JAMES A. FITZPATRICK NUCLEAR POWER PLANT

ENGINEERING CHANGE NOTICE

MOD: E1-90-013 ECN 022 SH. 3 OF 5
DOCUM: 11825-10.12-24 REV: 0
ENGR: R. Drake VERIF: [Signature] APPR: [Signature]

PLAN EL. 30
 SE A BLDG

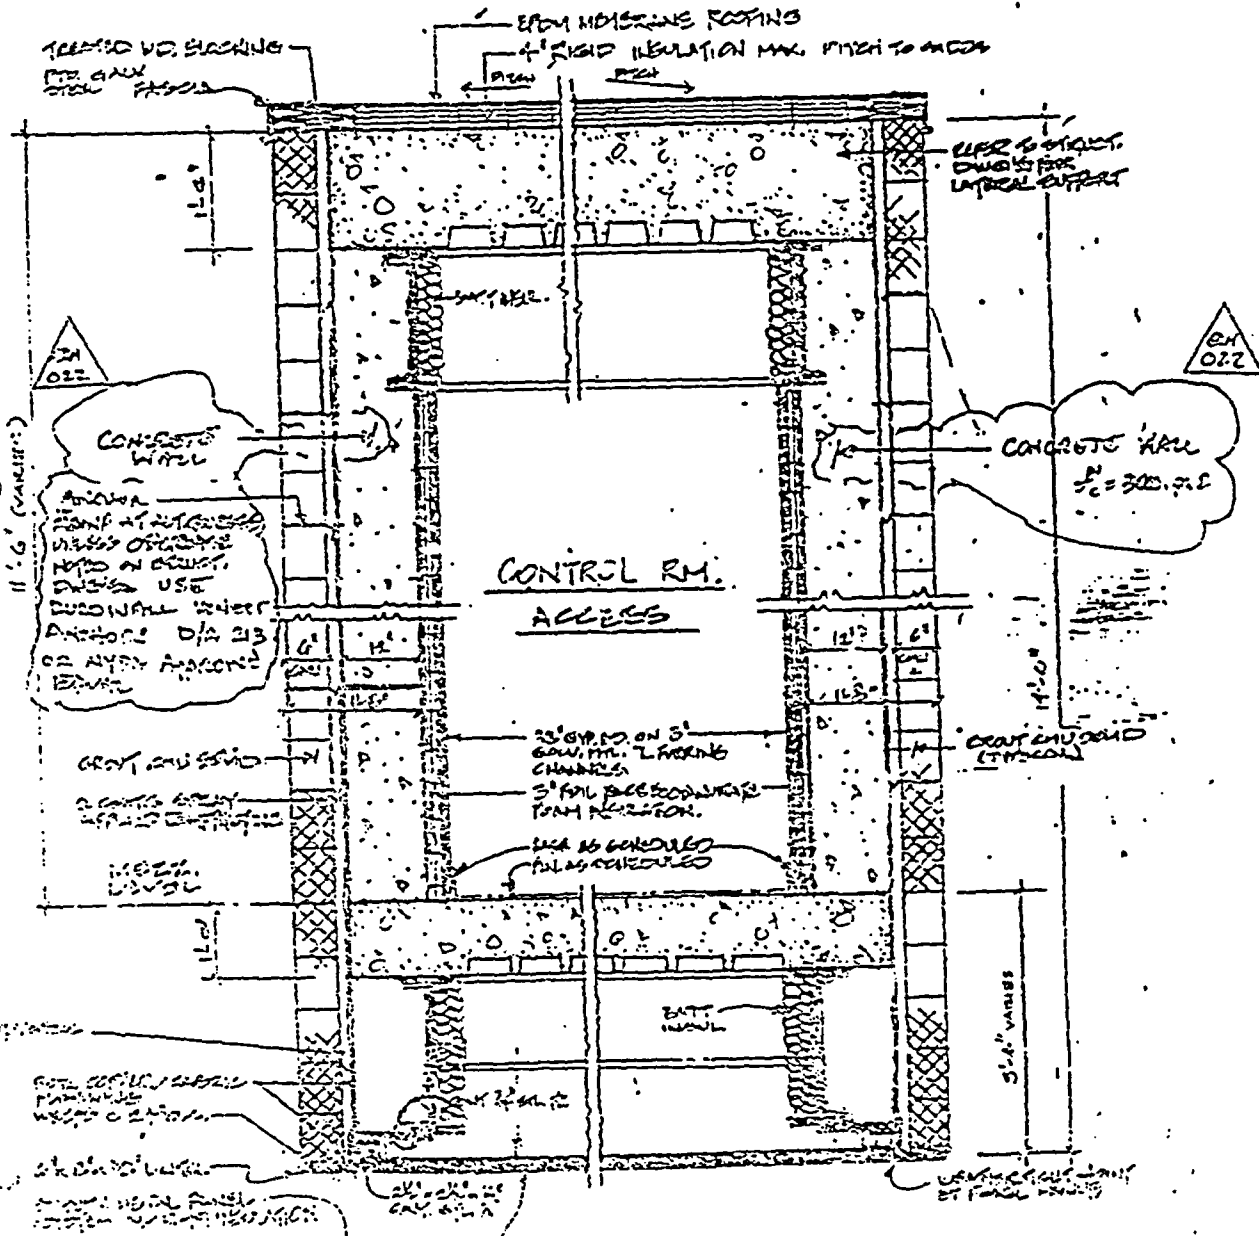
ACCESS
 BRIDGE
 (7/12.2-8)

ACCESS DOOR TO THE CONTROL ROOM FROM ADMINISTRATION AND SUPPORT BUILDING

SECTION 3

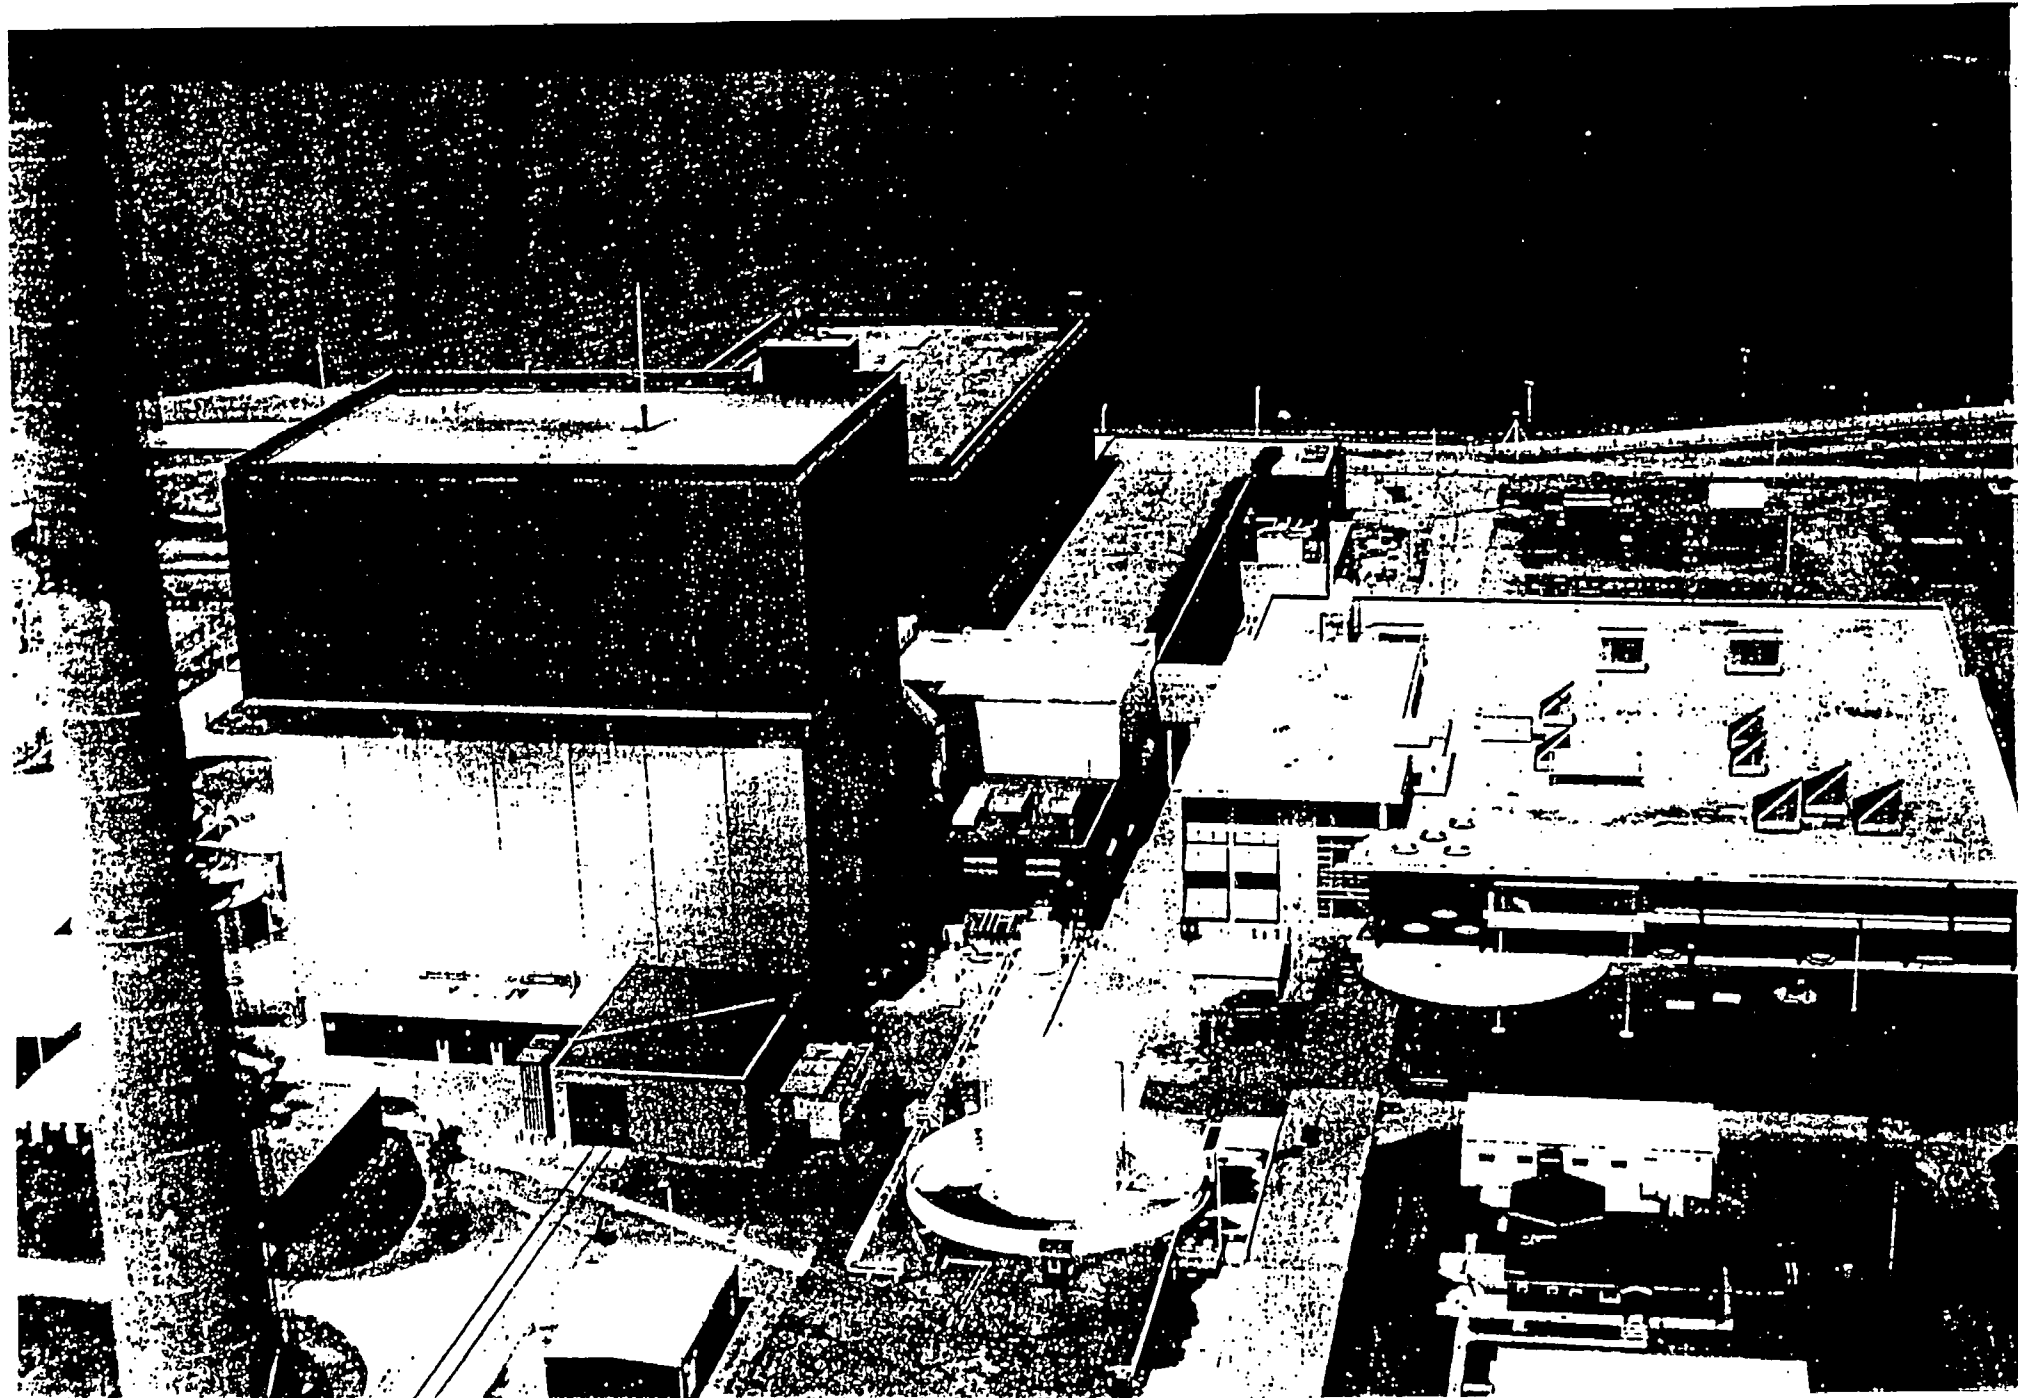
④ CMU WALL @ MEZZANINE/ROOF
7'4" x 10'
